SERVICE LETTER

SUBJECT: HARTZELL SERVICE BULLETINS HC-61-224, REV.2 - PROPELLER PART - STOCK INSPECTION AND HC-61-224, REV. 2 - PRE-LOAD PLATE SET-SCREW INSPECTION

SERVICE BULLETIN HC-SB-61-224

SERVICE BULLETIN HC-SB-61-225

FIGURE 1.
TYPICAL BLADE COMPONENTS SHOWING SET SCREW APPLICATION

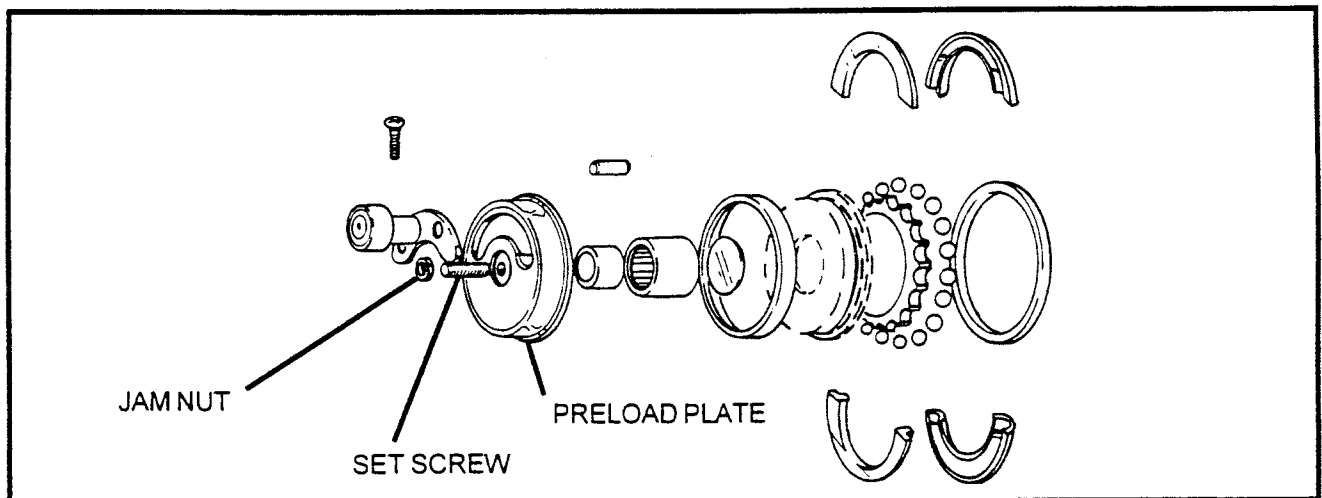
- (1) Manually rotate prop and listen for possible noise caused by a broken set screw/jam nut that may be loose in the propeller hub, see Figure 1.
- (2) With propeller blades in feather position, visually check feather stop nut to be seated, see Figure 2.
- (3) If noise indicates a loose part (broken set screw) or if the propeller blades do not go all the way into feather, remove propeller and send to a propeller repair station for disassembly and inspection for a possible broken preload plate set screw.
 - (a) If a broken screw is found after disassembly, the propeller must be disassembled and inspected for damage that may have been caused by the broken screw.
 - (b) Report any such incidents to the Hartzell Product Support Department.

- (1) Replacement of preload plate set screws with new screws is required.
- (2) Use of A-3204-2 Set Screws in lieu of the previously specified A-3204 Set Screws is recommended, except for HC-A6A-3 model which continues to use only the A-3204. Use of A-3204-2 is preferred, however, A-3204 remains usable if it meets the inspection requirements of Hartzell Service Bulletin HC-SB-61-224.

FIGURE 2.
FEATHER POSITION FOR 4, 5, 6 BLADE PROPELLERS

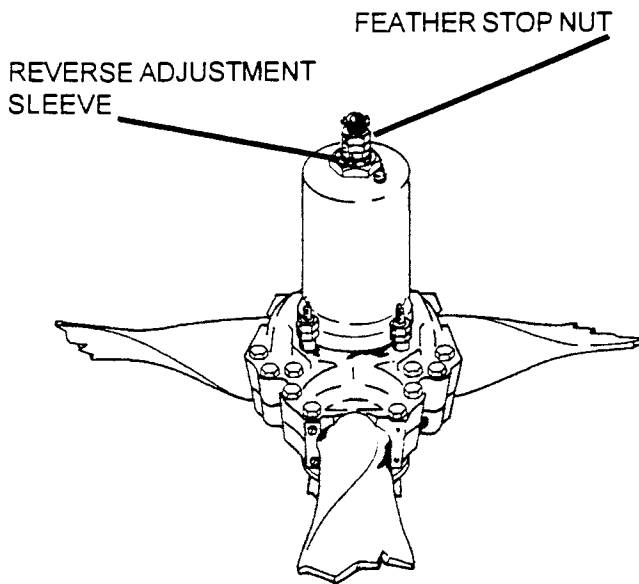
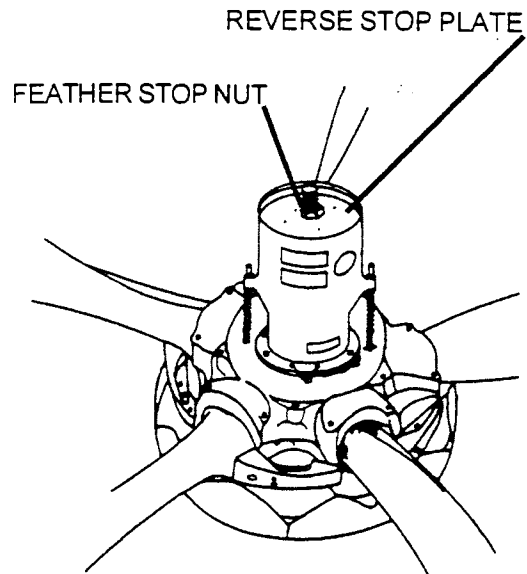
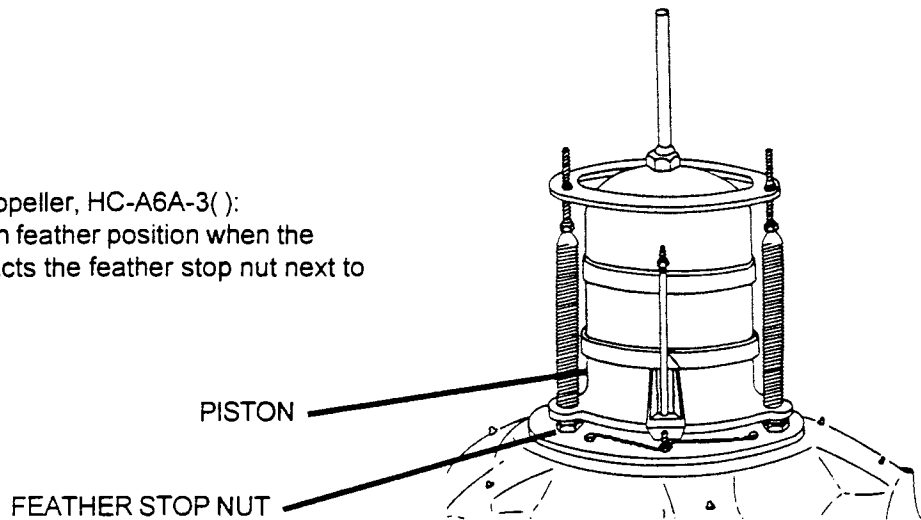
Four blade propeller, HC-(E,D)4(-):
Blades are in feather position when
feather stop nut contacts the reverse
adjustment sleeve.

Five blade propeller, HC-E5(-):
Blades are in feather position when
feather stop nut contacts the reverse adjust
plate.

Six blade propeller, HC-A6A-3():
Blades are in feather position when the
piston contacts the feather stop nut next to
hub.
